**Subject: Response to Second Request for Additional Information  
SCA Hartley & Hartley Landfill Site, Kawkawlin Township, Michigan  
NRC Source Material License No. SUC-1565**

### Responses to the USNRC's October 28, 2005 Request for Additional Information with Regard to the Decommissioning Plan for the SCA Hartley & Hartley Landfill Site Kawkawlin Township, Michigan

**Attachment 1B**  
**MicroShield Analysis**

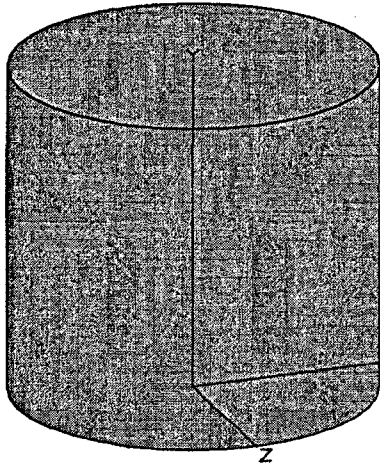
**Request #5:** *A dose analysis of the leachate collection system and the storage tank should be provided. In your DP, you indicated that a leachate extraction system will be installed in the Northwest Landfill and that the system would be used for an indeterminate period of time after the site had been released for unrestricted use. In your response to the RAI, you addressed the potential for exposure to*

radioactive contamination if the leachate system leaked during operation, the potential for exposure to contamination in the leachate piping during operation of the system, and the potential exposure of the workers to contaminated leachate in the storage tank. However, a dose analysis of exposure to the leachate collection system and the storage tank was not provided. Since you have requested that the site be released for unrestricted use, issues such as these regarding the operation of the system need to be addressed.

Response: S.C. Holdings concurs with the approach used by the Michigan Department of Natural Resources (MDNR) (and approved by the USNRC) to evaluate the potential radiological exposure from the leachate in the on-site storage tank<sup>(1)</sup>. Using the same approach, and incorporating radiological data for the leachate in the Northwest Landfill, as well as the projected potential levels of radioactivity in this leachate calculated using RESRAD, S.C. Holdings believes that future workers at the SCA Hartley & Hartley Landfill site will not be exposed to appreciable amounts of radioactive contamination stemming from operations involving leachate handling.

The USNRC's comment suggests that the unique properties of gamma radiation present an additional exposure pathway that does not require direct human contact with the leachate. The USNRC hypothesizes that the penetrating gamma radiation pathway (external pathway) could result in exposures to workers or visitors even if no leakage or direct contact with the leachate occurs. In response to the USNRC's concern, S.C. Holdings has formulated and evaluated an exposure scenario to address this potential exposure pathway. The exposure scenario involves an industrial worker who hypothetically stands 1 meter from the leachate storage tank for an entire work-year. In this scenario, the limited sections of the leachate transfer piping that extend above grade were not included because the vast majority of the leachate transfer piping is, and/or will be, buried below grade, and because it is more conservative to assume that a worker spends all work hours standing next to the larger source.

In addition, it was assumed that the 15,000-gallon leachate storage tank that was installed at the site this past summer to collect leachate from the East Landfill is used to collect leachate from the Northwest Landfill and the MDNR Landfill, as well. To be conservative, it was assumed that all of the leachate in the storage tank was extracted from only the Northwest and/or MDNR Landfills. (This is a simplifying conservative assumption because the thorium-bearing slag that was disposed in the Northwest and East Landfills was not known to have been disposed in the East Landfill. Ultimately, the contents of the storage tank will be a mixture of the leachate from each of the three landfills; however, the relative contribution from each landfill is difficult to predict and will likely vary over time.)

The modeled scenario was made even more conservative by assuming that the tank is always completely full (an impracticable, but simplifying and conservative, assumption), and that the concentration of residual radioactivity in the leachate is the maximum concentration projected over the 1,000-year outlook by RESRAD using the "system leakage" scenario. The "system leakage" scenario is also conservative, in that it assumes the presence of thorium radioactivity in slag at the specific activity limit.

The MicroShield computer modeling code (Version 5.01) (Grove Engineering, 1996) was used to assess the radiological exposure conditions resulting from a gamma radiation source. The MDNR used MicroShield in their analysis of the same exposure scenario. Under the above highly conservative exposure scenario, MicroShield projected a maximum potential gamma radiation exposure on the order of  $10^{-3}$  mrem/hr for a worker who hypothetically stands at a distance of 1 meter from the tank for an entire work-year. This converts to an annual gamma radiation dose of less than 2 mrem/yr (based on approximately 2,000 work hours per year). The results of this analysis are attached (see Attachment 1B) for the USNRC's review and consideration.
